East Anglia ONE North Offshore Wind Farm

Appendix A23 to the Natural England Deadline 11 Submission

**Natural England's Response to London Array OWF Year 3 Ornithological
Monitoring Report**

Planning Inspectorate Reference: EN010077

Figure 6 Red-throated diver mean density (birds/km²) within the SPA, excluding the areas within the footprints of wind farms (SPA (-WF)), and within those windfarm footprints (WF) for Survey 1 and Survey 2.

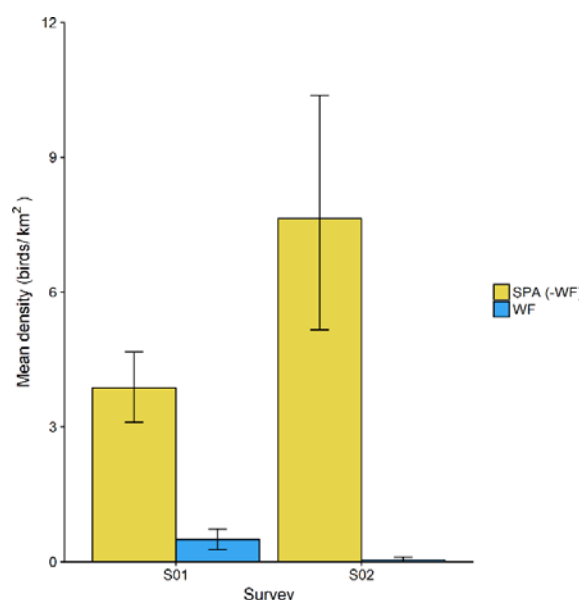
strong displacement of red-throated divers from areas within offshore windfarms and from areas of shipping activity. This has led to higher densities of birds at points furthest from anthropogenic activity. This can be seen visually in the number of diver detections and the modelled diver density surface shown in Figure 8 of Irwin et al (2019) and in the pronounced difference in diver density between areas inside windfarm footprints within the SPA and areas outside those footprints as shown in Figure 6 of Irwin et al (2019). These figures are reproduced below:

These surveys indicate that displacement of red-throated divers from LAW and its immediate surroundings continued to be detectable in early 2018 – two years after the conclusion of the post-construction monitoring programme at LAW, and four and a half years after LAW was fully commissioned.
